BUILDING PERMIT

This is to certify that GRANDVIEW M & M LLC / Specialty Pro Construction
has permission to Build New 3 bedroom w/(1) full bath (1) half bath 24' x 16' (2) story home w/ 10' x 10' deck NO garage
AT 0 DEDHAM ST City of Portland
City of Portland
336 D003001

City of Portland, Maine - Building or Use Permit Application

RE: Grandview M&M, LLC, Dedham Street

Dunham Street Portland Me.		
SCALE 1/4"=1'	APPROVED	DRAWN BY
DATE February 02, 2010		REVISED 7/1/10
Mainly Properties		DRAWING NUMBER
Floor Plans		A-1

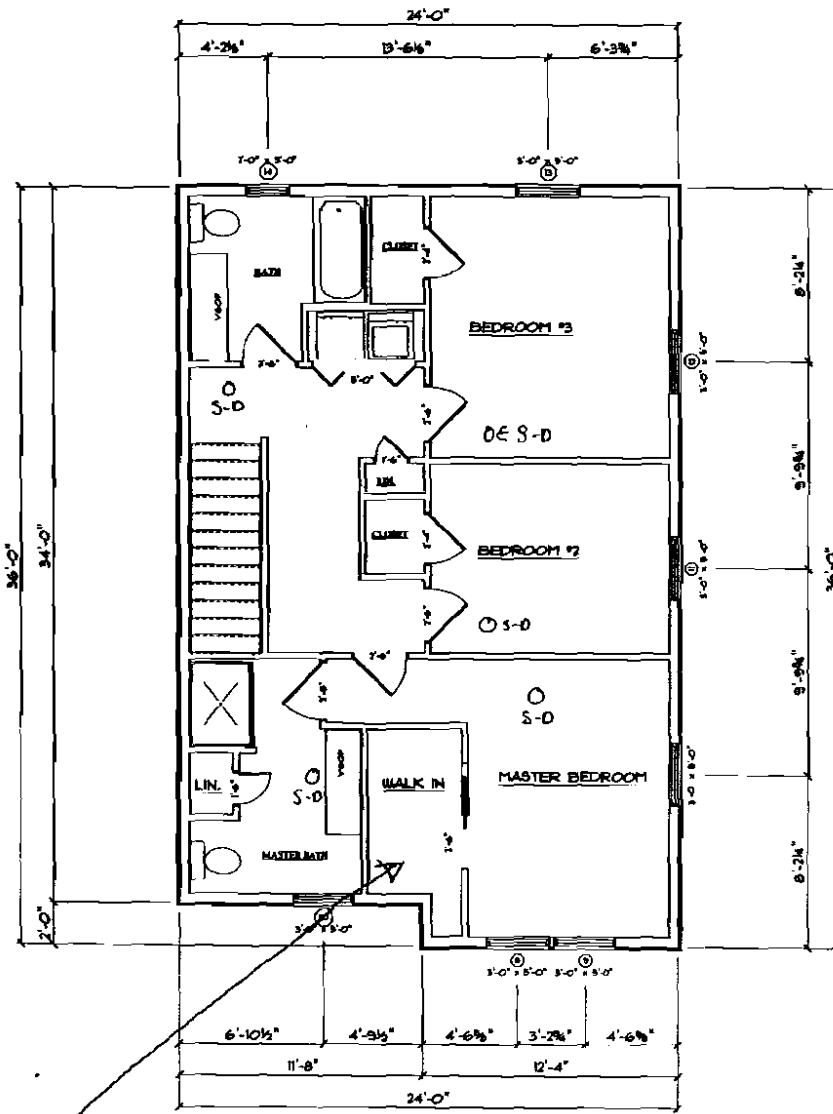
NO GAS FIREPLACE
UNLESS AN UPSELL

SITE/GRADING PLAN

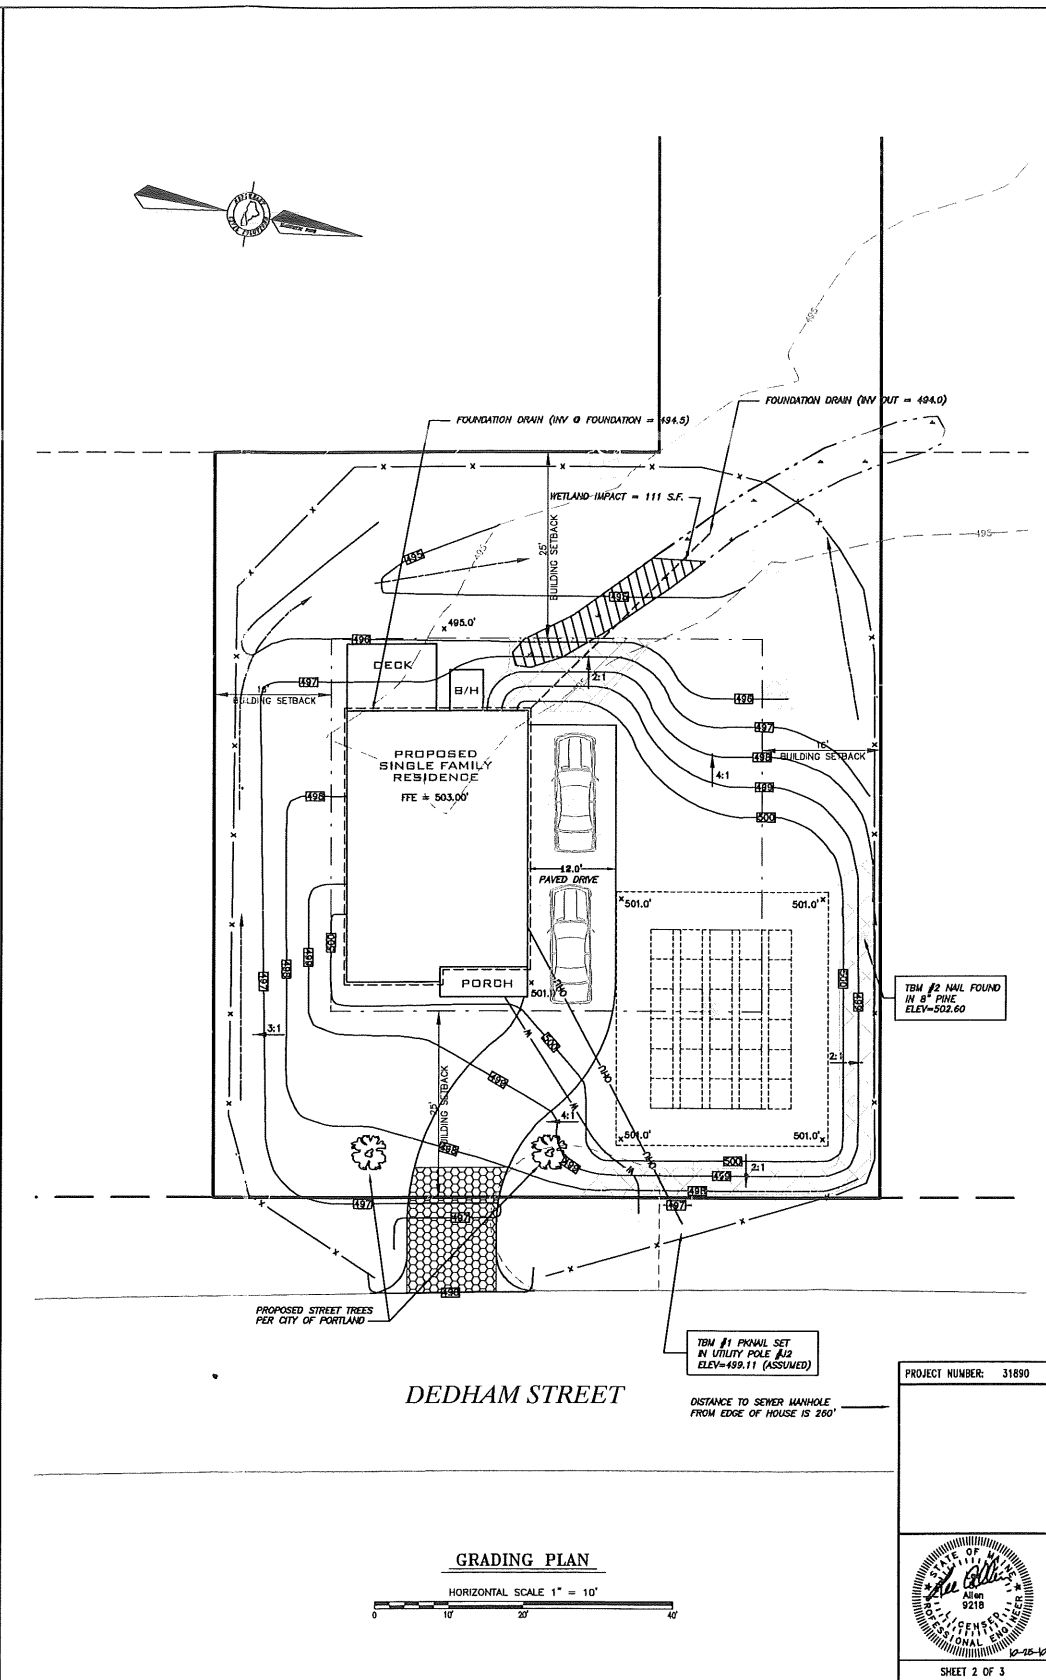
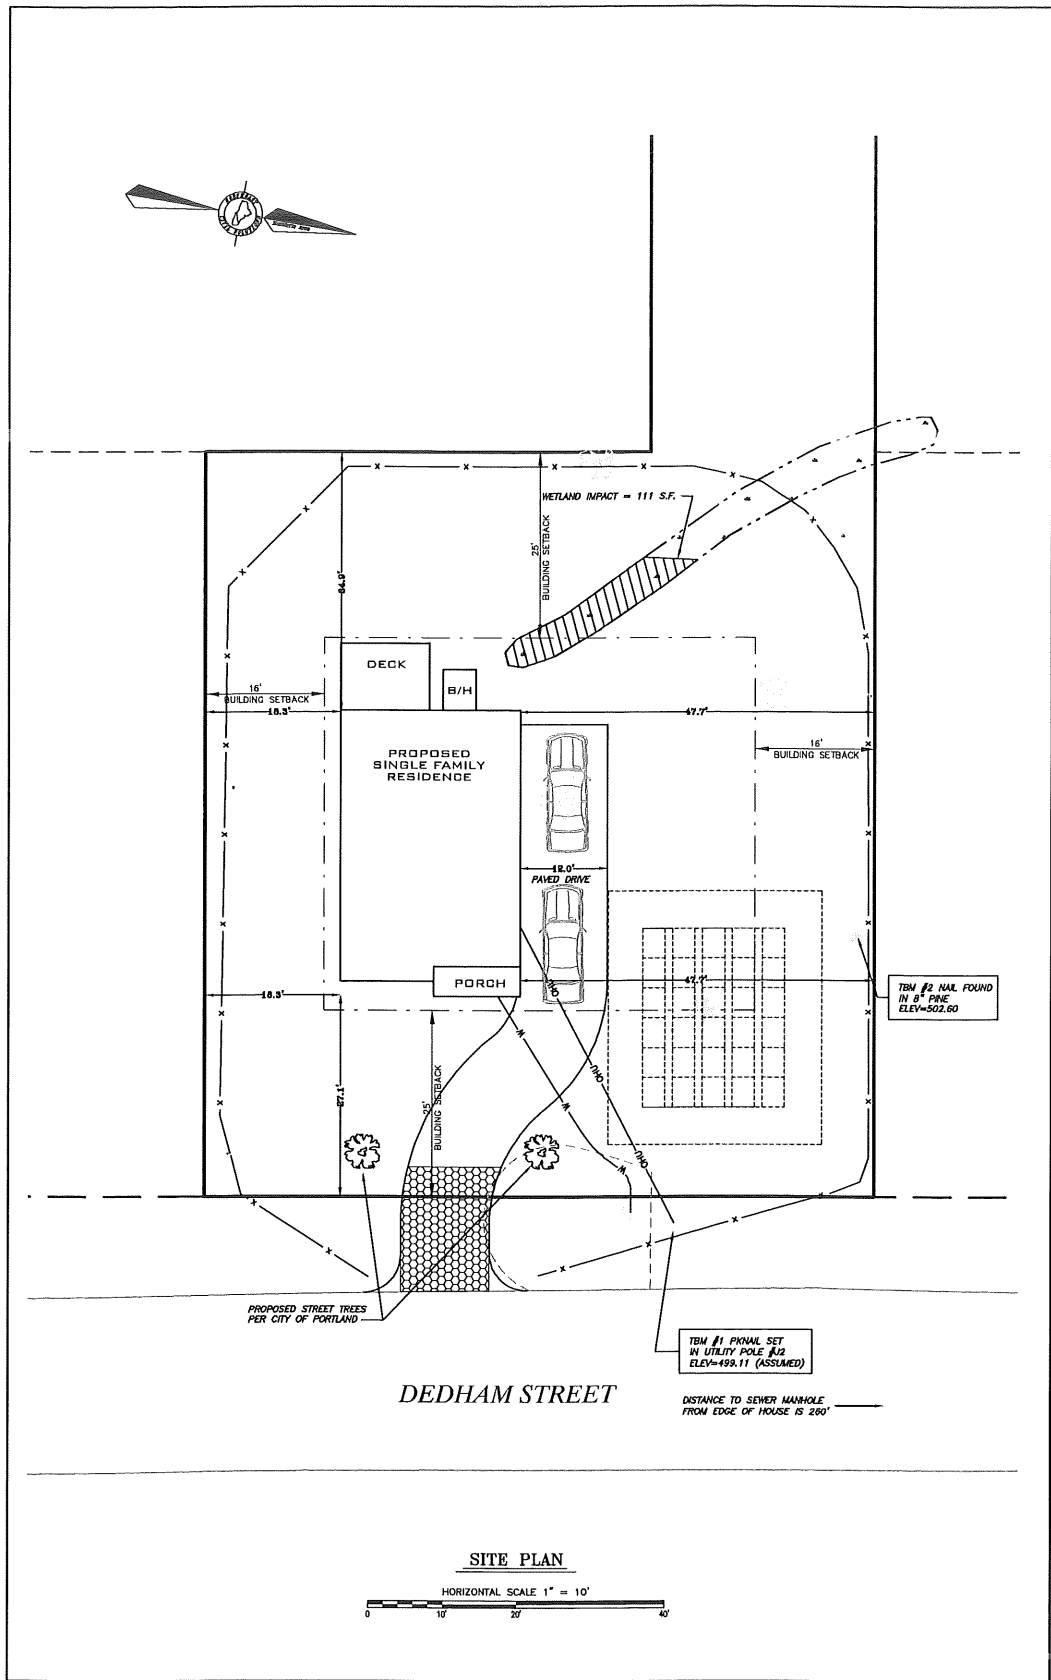
1. Send a .pdf of the site plan to the Planning Office. A .pdf copy of the site plan **has been emailed to Ann Machado and you.**
2. The footprint of the house plan does not match the plan. **This has been corrected the floor plan now matches the architectural plans.**
3. Do not show the location of the future garage. **The dashed footprint of the future garage has not been shown.**
4. The deck and front entry do not show up on the site plan. **The building was moved forward and now indicates a deck and front porch as shown on the architectural plans.**
5. Applicant must show room to park two cars beyond the setback. **Two cars are shown parked beyond the setback (A distance of 38 ft, 19 ft per car was used).**

1. The driveway must be 12 feet in width. **The driveway has been revised to 12 ft width.**
2. A foundation drain outlet should be provided. **A foundation drain has been shown with an outlet invert elevation of 494.0.**
3. Sewer must be more than 200 feet away in order to use a septic system. **A note has been added to the plan that the nearest sewer from the edge of the building is 262 ft away.**
4. All 2:1 slopes must be stabilized. All 2:1 slopes, indicated by hatch on the plan, are to be treated with erosion control matting.
5. Property pins not found during boundary survey shall be set. **On the boundary plan (Sheet 1 of 3) solid circles indicate that four property pins must be set.**

Revised	By	Date	Change
1	SA	10-20-18	REVISED HICK & BARDEN LOCATOR PER CLIENT
1	SA	7-18-19	REVISED PER CITY OF PORTLAND COMMENTS

DUNHAM STREET, PORTLAND ME		
SCALE 1/4"=1'	APPROVED	DRAWN BY
DATE February 02, 2010		REVISED
MAINLY PROPERTIES, INC		
FLOOR FRAMING PLAN	DRAWING NUMBER	A-3

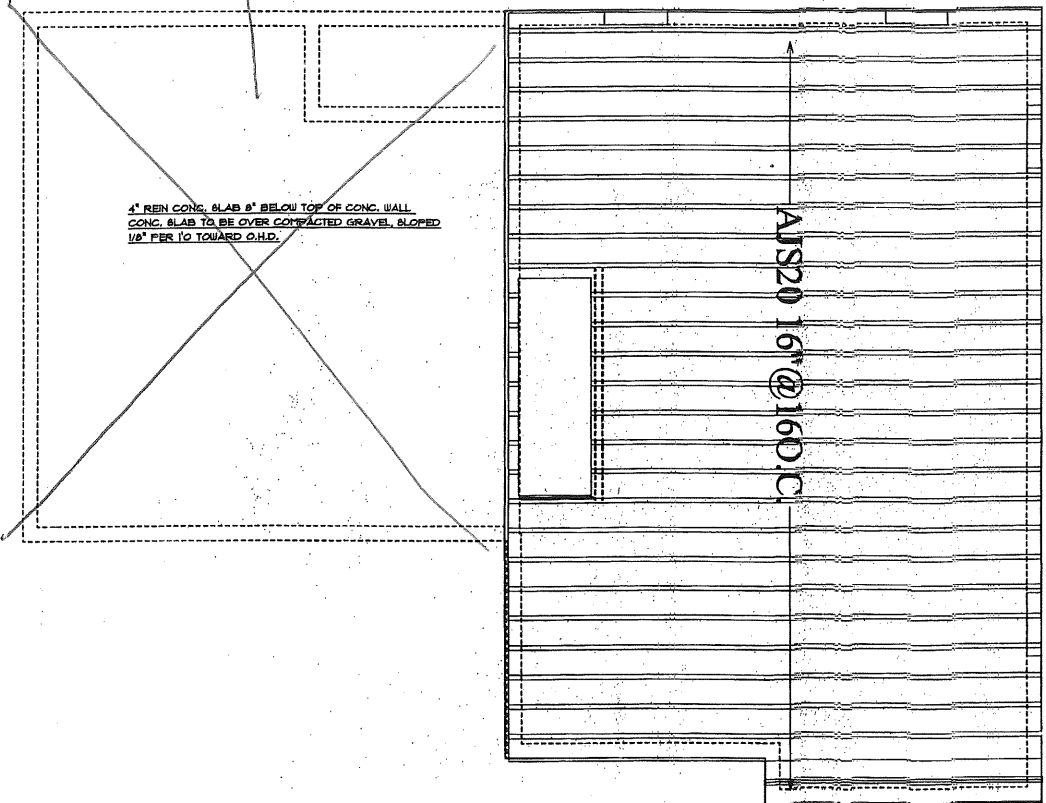
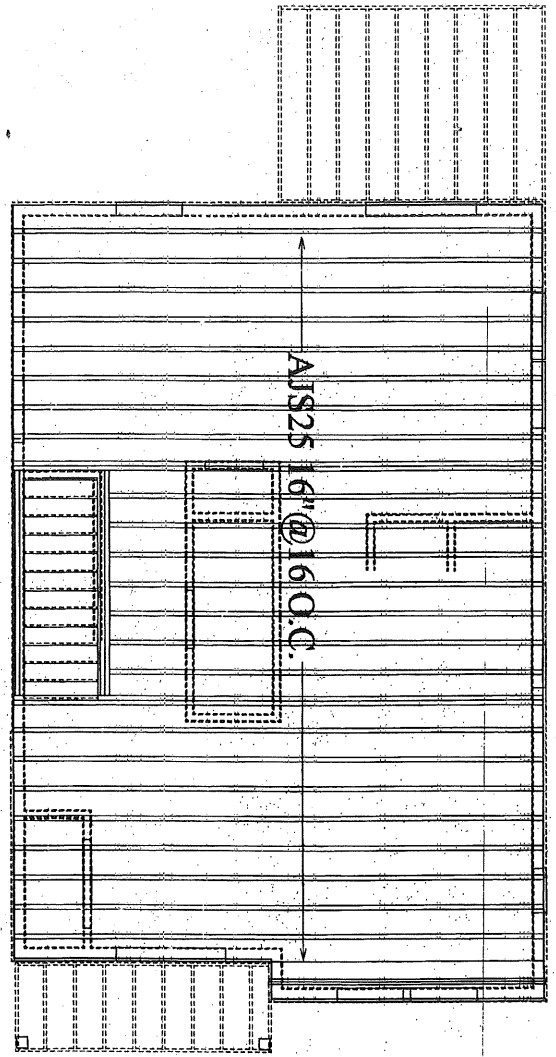
-Is the garage being built at this point or not - says future garage on siteplan, shows foundation for garage but no structural plans & not on elevations - if not building it now remove it from site plan and from foundation plan.

Not part of
this permit
with apply will need to
apply for separate
application to build garage
infrastructure

DUNHAM STREET, PORTLAND ME		
SCALE 1/4"=1'	APPROVED	DRAWN BY
DATE February 02, 2010		REVISED
MAINLY PROPERTIES, INC		
FOUNDATION PLAN	DRAWING NUMBER A-2

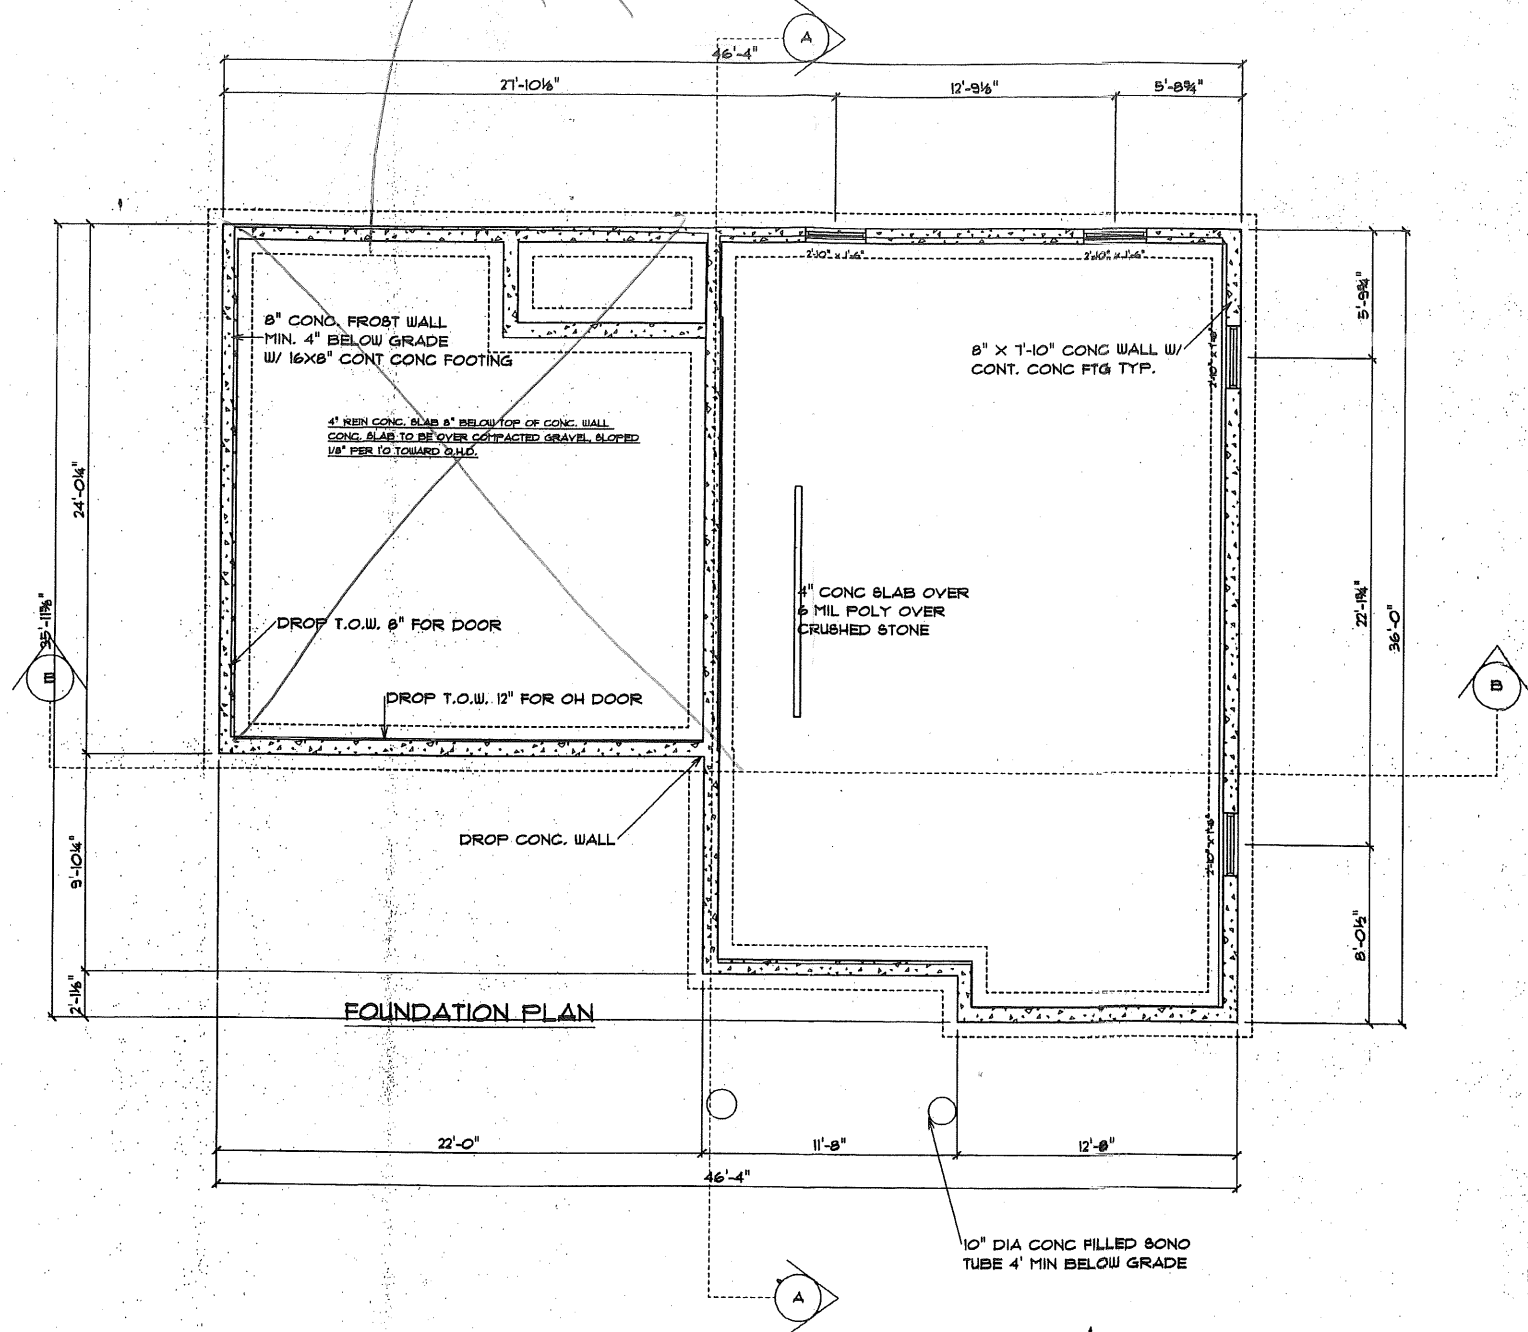
Not part of this
 permit - see building
 plan received 7/20/19
